TO: Chairman Susanke and Members of the Planning and Zoning Commission
FROM: Timothy J. Scott, AICP, CNU-A – Community Development Director
Atrin Fard, Village Planner 
DATE: November 25, 2019
SUBJECT: Public Hearing – Petition 19-15: Special Use for Senior Citizen Housing and Retirement Home in the B-3 Business-Service District, Zoning Variations for Building Height and Driveway Curb Cut Width, and a Preliminary Plat of Subdivision

The petitioner, Nelson Construction and Development, is requesting: (1) a Special Use for senior citizen housing and retirement home (an assisted living and memory care facility); (2) a Zoning Variation for building height; (3) a Zoning Variation for driveway curb cut width; and, (4) a Preliminary Plat of Subdivision for the purpose of constructing a 126-unit senior housing development on nine (9) acres of vacant lot located at the southwest corner of Angle Tarn Road and Illinois Route 31.

**CANTERFIELD FARM SENIOR LIVING
 VILLAGE OF WEST DUNDEE, ILLINOIS
 PLANTING PLAN**

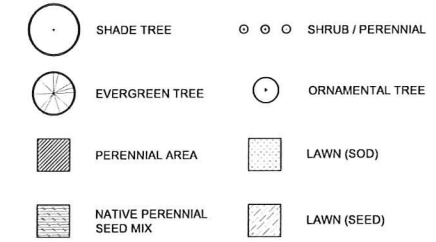
With respect to the buffer, it appears that the space is planned at approximately 30', with approximately 10' for the trail area [eight feet for the pavement and two (2) feet of turf] and 20' planned for the landscaping, which should provide a wide enough area to establish healthy trees, shrubs, and other plant material. Of particular interest is the screening capability of the selected materials. The preliminary plan shows at the approximately 36 trees, with 16 evergreen, 14 ornamental, and six (6) shade.

Given the primary objective of screening, it may be worth considering rebalancing the material mix so as to increase the number of evergreen trees, with attention paid to size at planting and

**CANTERFIELD FARM SENIOR LIVING
VILLAGE OF WEST DUNDEE, ILLINOIS
SITE DIMENSIONAL AND PAVING PLAN**

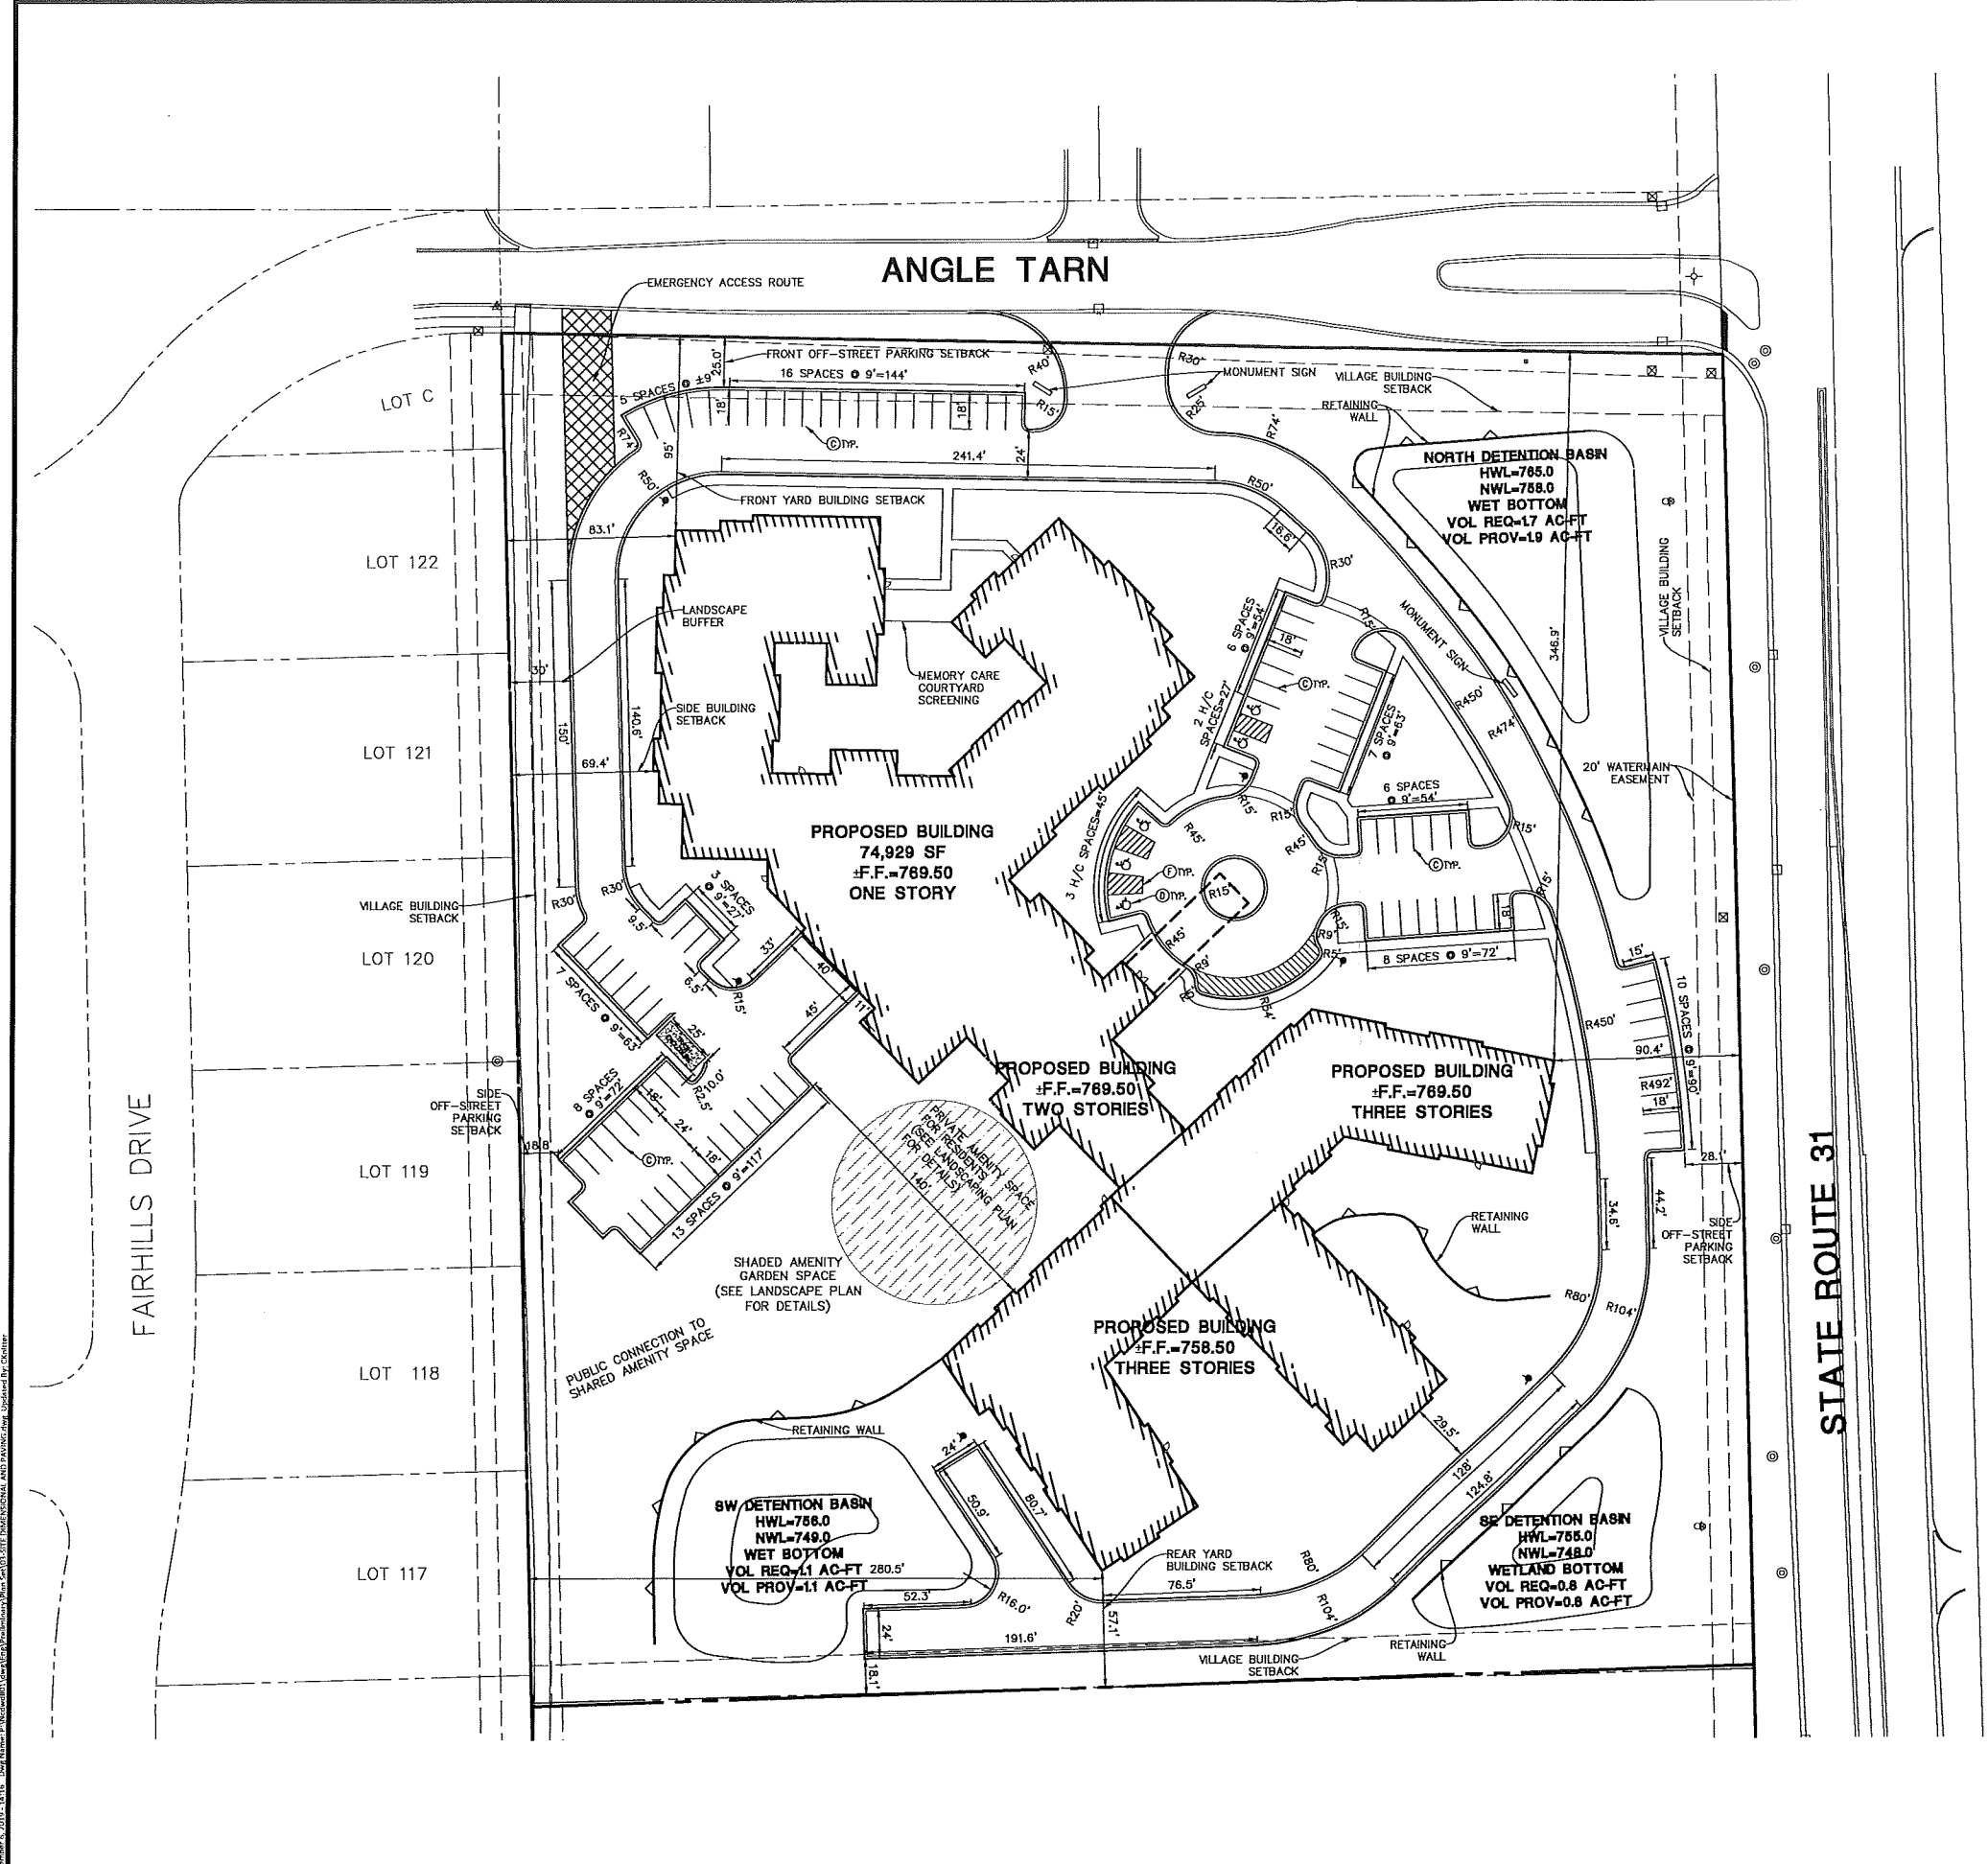
The development's primary access would have a curb cut on Angle Tarn of approximately 50' in width and aligned with the southern access of First Congregational Church. The maximum width permitted by code for an entry drive is 24'. With this in mind, a variation of driveway curb cut width is requested. As shown in the preliminary plan, the entry does not have a planted median. For reference, the now under-construction Seasons at Randall Road's primary access was approved with a planted median (40.5'-wide entry including a 12.5'-wide median), as was approved for the completed Springs at Canterfield (52'-wide entry including a 12'-wide median). A planted median typically adds formality and an enhanced sense of arrival.

Section 10-9-1-5: Code requires that a private driveway/curb cut open to a public street shall not exceed 24' in width at the property line and that a divided driveway with a landscaped median exceeding 24' in width must be submitted to the Village Board for approval. The proposed entrance into the development off of Angle Tarn Road is approximately 50' with no landscaped median. As previously covered in the "access..." section, the Springs at Canterfield and The Seasons at Randall Road received approval for their 40.5'-wide and 52'-wide entries, both of which have planted medians.
